Kent Historic District Commission
Minutes of special meeting on September 18, 2017

- I Jeffrey Morgan and Anne Todd were elevated to voting status.
- II. Modifications to the property of: James Anderson and Deidre Keogh-Anderson
5 Cobble Road
Kent, CT 06757

5 COBBLE ROAD - SCHEMATIC DESIGN

Town of Kent
Historic District Commission
Application for a Certificate of Appropriateness
MODIFICATION

Ell plan - proposed

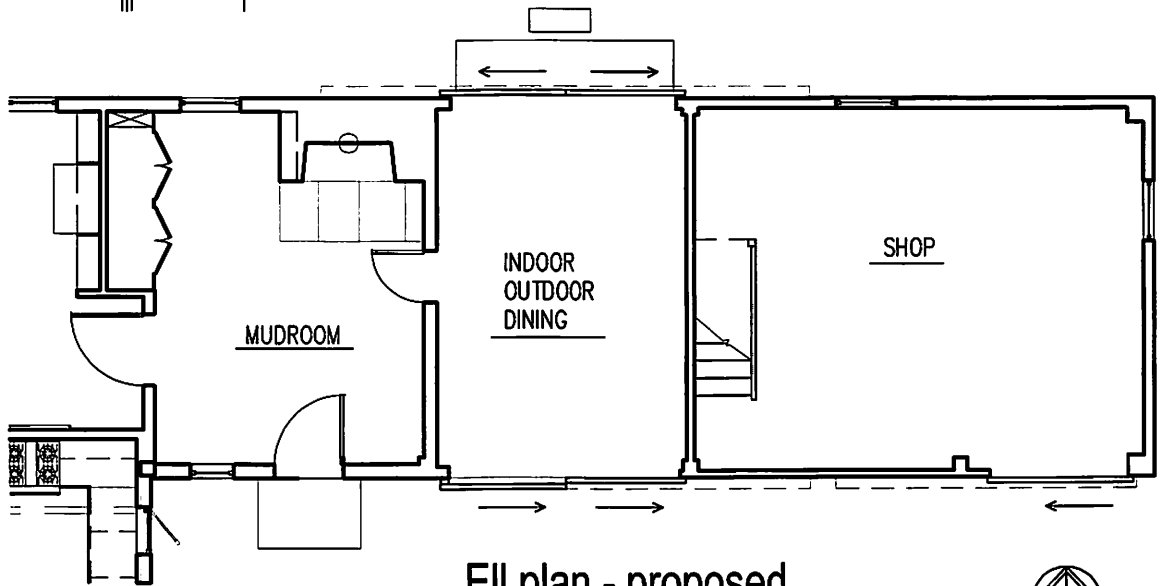
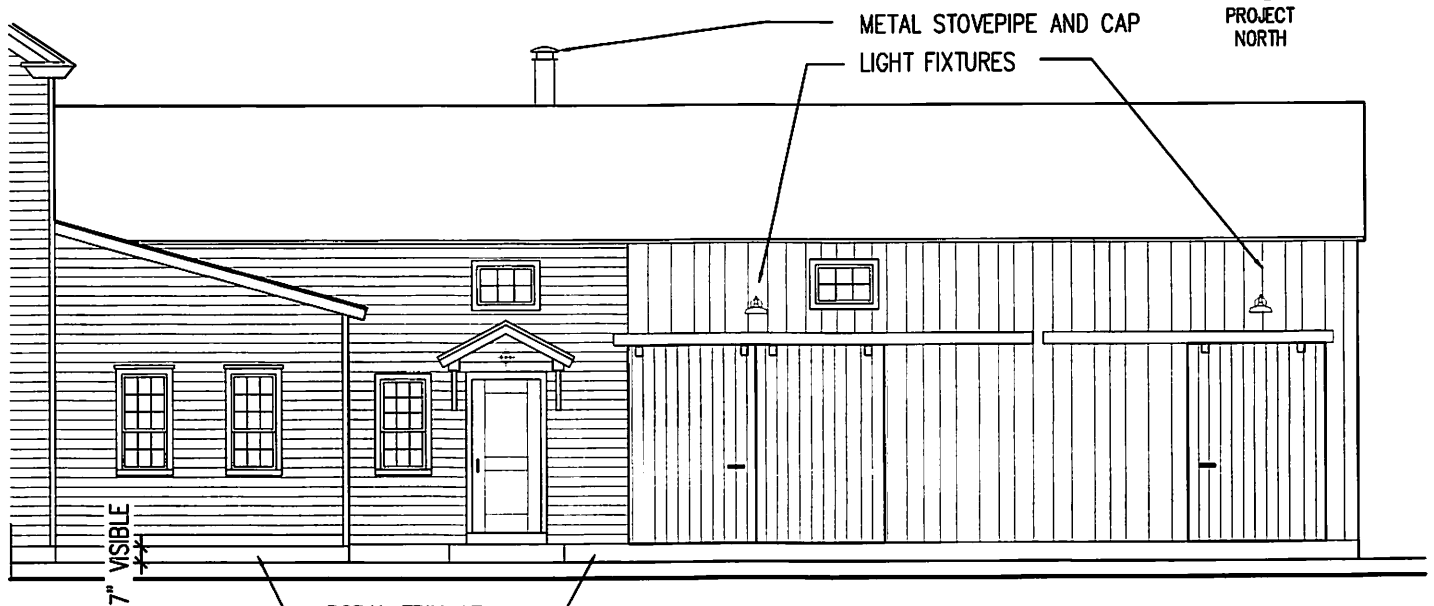
4. Sliding doors on the south side of the ell are appropriate as submitted.
5. The proposed light fixtures are appropriate as submitted. It was noted that the Commission does not regulate residential light fixtures.
6. As an alternate to the proposed Boral board facing on the foundation, the HDC recommends a parge coat on the existing foundation.

- Removal of Shed/former outhouse located to the east of the ell, due to its deteriorating condition.
- Ell, south side - modifications to the sliding barn doors to the indoor/outdoor dining area and the shop. A dimensional discrepancy (my mistake) on the existing drawings did not allow room for the proposed door track for the indoor/outdoor dining area. We propose that both of these slide to the north instead of parting at the center. Additionally, to maximize light and air to the dining, we request raising that same door head height from 6’-5” above the sill (which does not meet code) up to the existing structural timber above, which is at 8’-4” above the sill.

5 Cobble Rd before chimney replacement

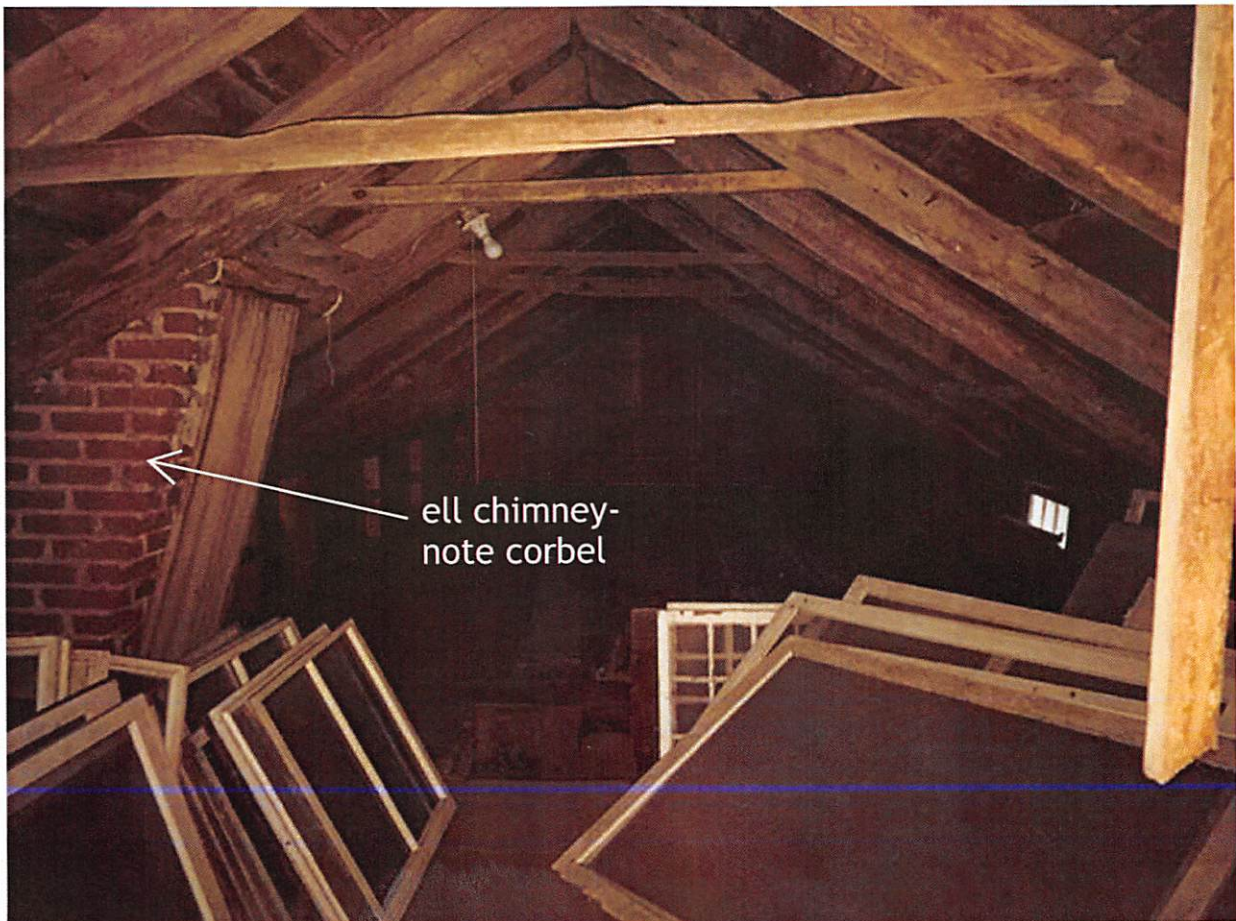
1. The commission voiced objections to the modifications that have been made to the chimneys on the front section, in contradiction of the Certificate of Appropriateness and recommended the following remedies:

- a. The chimneys should be modified so that the front-facing sides of the exterior masses are positioned at the ridge of the roof.
 - b. Premier color (e.g., ivory) mortar should be used to give an older appearance.

- c. If capped, the caps should be authentic, of material such as arched steel, stone or brick, with arch axis perpendicular to the roof ridgeline.
2. The replacement metal chimney that has been proposed on the ell section is not consistent with the Certificate of Appropriateness. The replacement chimney should be masonry similar to the one that was deemed unsound and dismantled. Its position may be adjusted closer to the eave of the roof. It should be constructed of brick with Premier mortar, both matching the front chimneys.

Thank you for contacting me regarding the chimneys at 5 Cobble Road in Kent. I was remiss in not contacting you when it became apparent that the existing chimneys, for various reasons, were not going to be usable and would need rebuilding with their locations modified.

1. The existing chimneys, once the plaster and interior finishes were removed, were discovered to be structurally unstable (cracks and disintegrating brick, and also some voids existed in the supporting structure in the basement). Lack of any "cap" on the chimneys meant rainwater entering the flues had contributed to deterioration. They were one brick width thick and were unlined. We enlisted the services of our structural engineer, Jim DeStefano, to design appropriate fixes to the unstable foundations of both chimney masses and to ensure the stability of the chimneys up through the house. The situation was also reviewed with Building Inspector Bill Jenks regarding making the chimneys code compliant.

2. Both chimneys had a pronounced corbel in the attic which does not meet current code. Current code only allows for a few inches of corbel.
3. The northern chimney and one of the north fireplaces (there are two back-to-back in the living areas) had been compromised to accommodate the furnace flue. One had been bricked up, and the other closed up and appeared not to have been used.

exterior fixture for ell,
south and north sides

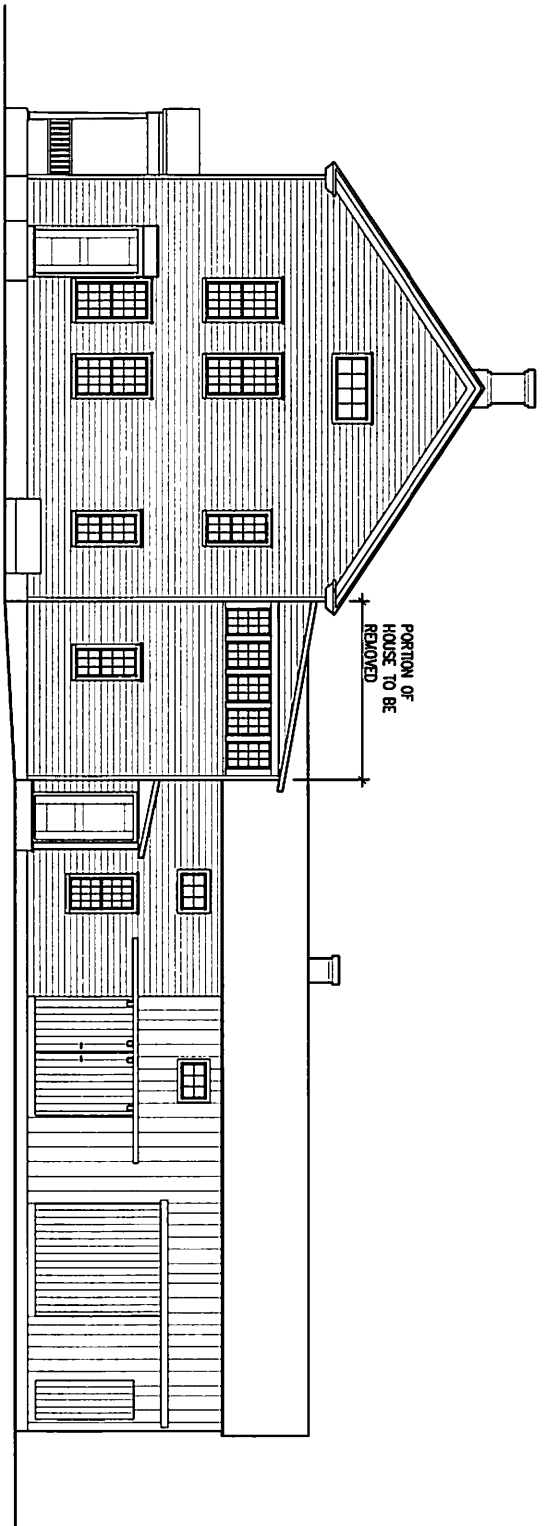
- Approval for exterior light fixture type that has now been selected. Please see attached cut and elevations.
- Kitchen addition - The visible portion of the foundation of the new kitchen addition is called out as “stone”, we request change to “Boral” trim. A sample will be provided. Due to anticipated final finished grade, the visible portion of the foundation wall will be about 7” maximum.
